1968 - 1972 Corvette: Service News: Rear Bow Lock Spring Replacement

Subject: Rear Bow Lock Spring Replacement

Model and Year: 1968 - 1972 Corvette Convertible

Date: January 1972 - Volume 44, Issue #1

Fig. 5-Corvette Bow Lock Spring

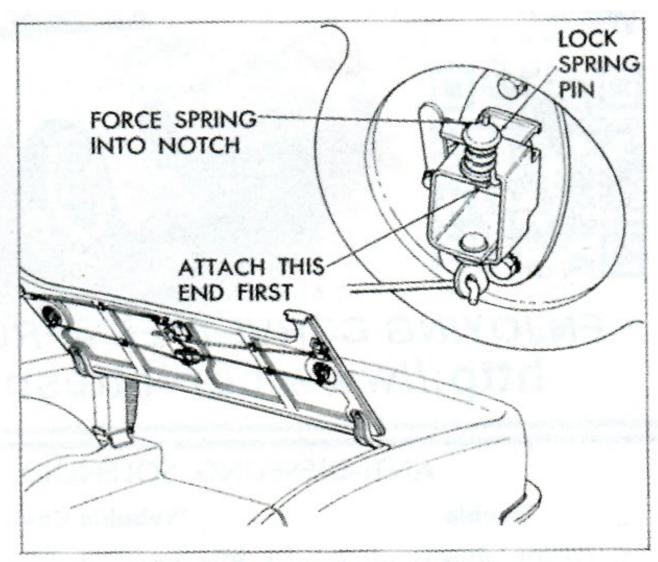
Folding top rear bow lock springs have been released as service parts for 1968 thru 1972 Corvette convertible models. Previously, the springs were replaced only as part of the left or right side bow lock assembly.

In the event of a bow lock spring failure, install Spring - Part No. 3942773 (left side) and/or Spring - Part No. 3942774 (right side) as follows:

- 1. Thread the spring, hooked end first, onto lock spring pin.
- 2. With catch in locked position, attach hooked end of spring into housing body (Fig. 5).
- 3. Using needle nose pliers, force the straight end of spring into the holding notch of pin.
